# Planning Commission Staff Report

MASTER PLAN AMENDMENT CASE NUMBER: WMPA21-0002 (Village Green Commerce Center Specific Plan)

BRIEF SUMMARY OF REQUEST: To amend selected development standards for the existing Village Green Commerce Center Specific Plan

Figure D-5: Buffering Yard Planting Plan

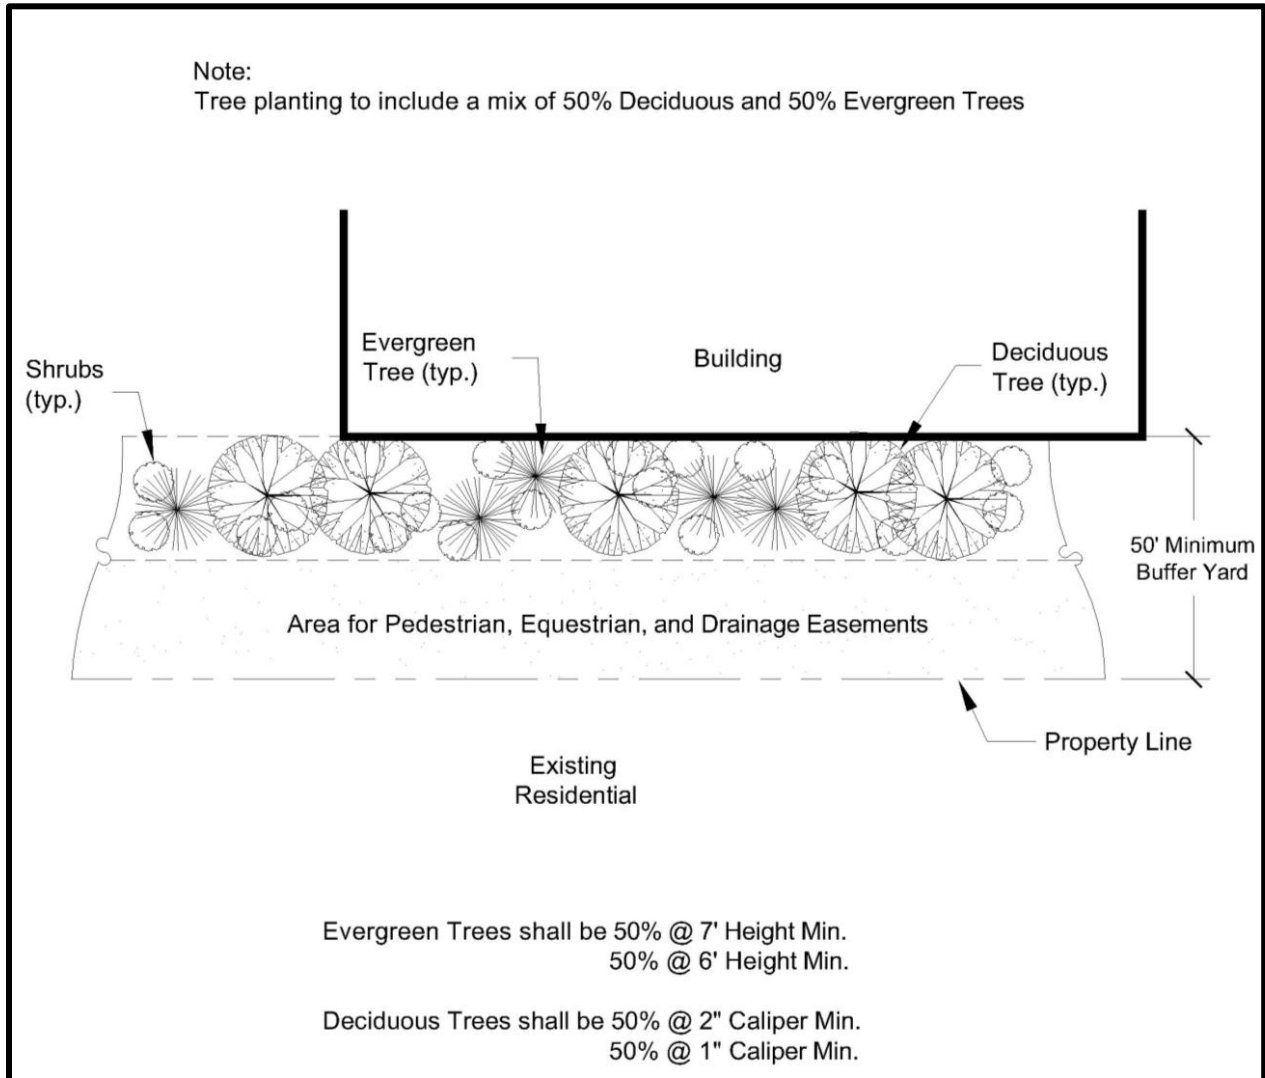
- Removal of Figure D-5: Business Park Buffering since the equestrian easement has been removed; and
- Updated language concerning the Transportation Improvements section in accordance with Washoe County Engineering and Capital Projects. The new wording is the following: The Village Green Commerce Center will be required to improve Calle de la Plata to a commercial collector roadway standard from the easterly project boundary to the Pyramid Highway right-of way (ROW). Prior to the submittal of a building permit, each developer shall enter into an agreement with Washoe County stipulating the improvements to be constructed by the developer and the timing of construction of said improvements to the satisfaction of the County Engineer.

Figure D-6 5: Buffering Yard Planting Plan

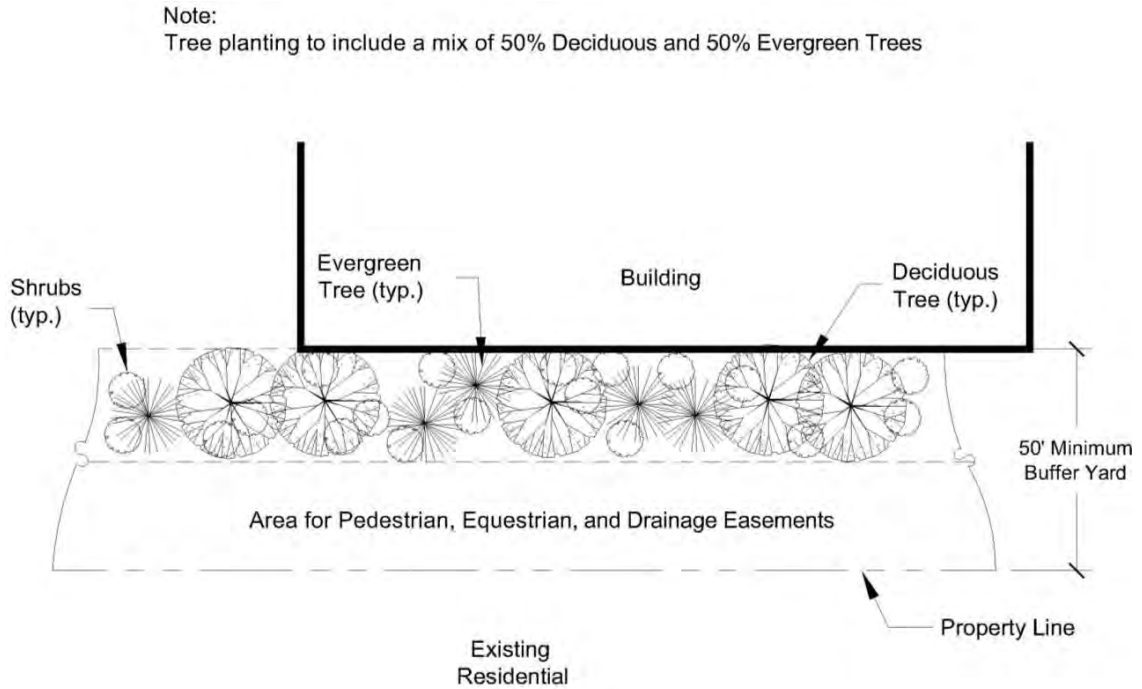
11. Remove Figure D-5: Business Park Buffering;
12. APN: 534-561-10 is exempted from Low Impact Development (LID) Standards and Environmental Sustainability Standards
